DMPS CENTRAL CAMPUS GYMNASIUM AHU REPLACEMENT

PROJECT NUMBER
20165449

DRAWING REFERENCED:
ADDENDUM NO.:

M4.00
1

SKETCH
MD-01

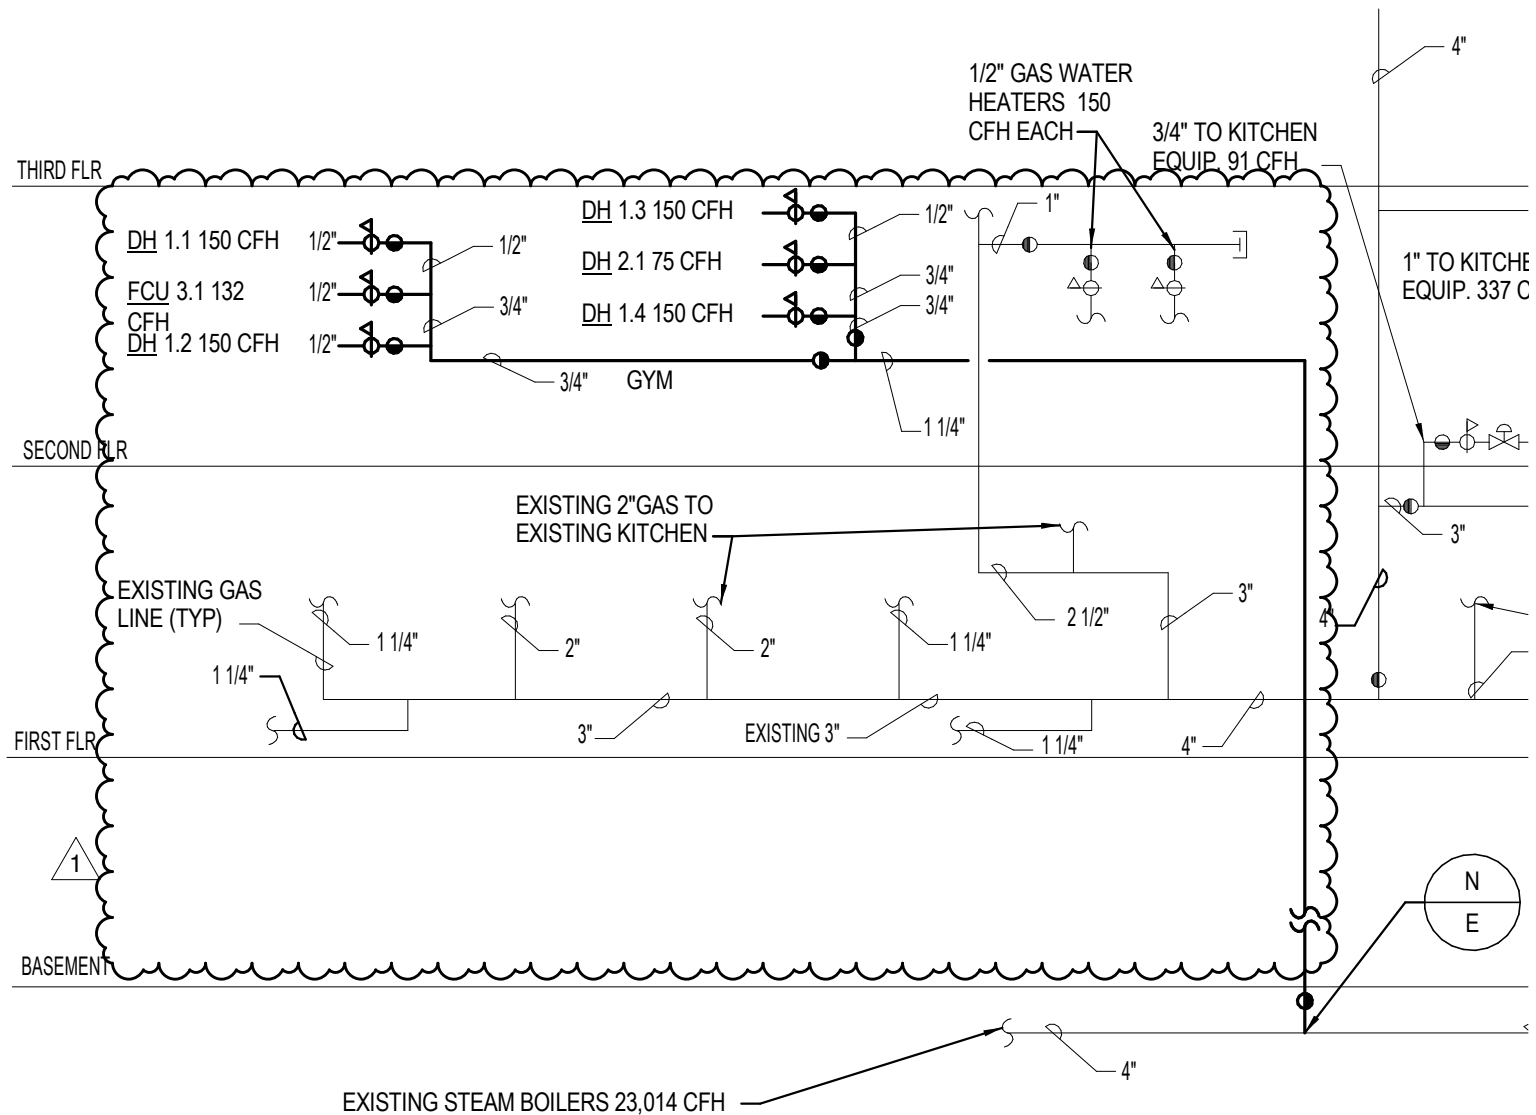
1. Modify Gas Piping Riser Diagram. See Supplemental Drawing MD-01 for additional information.
2. Detail 2/M4.00 – see attached sheet S1.1 for support structure for mechanical units

SKETCH
MD-02

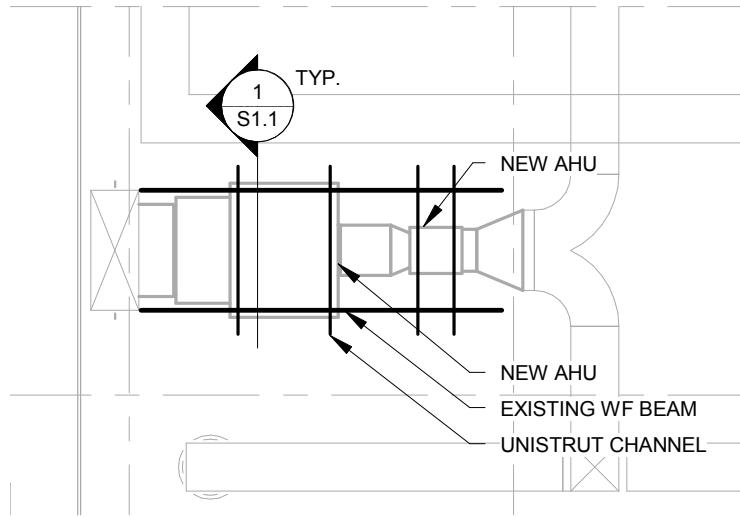
1. Modify Fan Coil Unit Schedule. See Supplemental Drawing MD-02 for additional information.
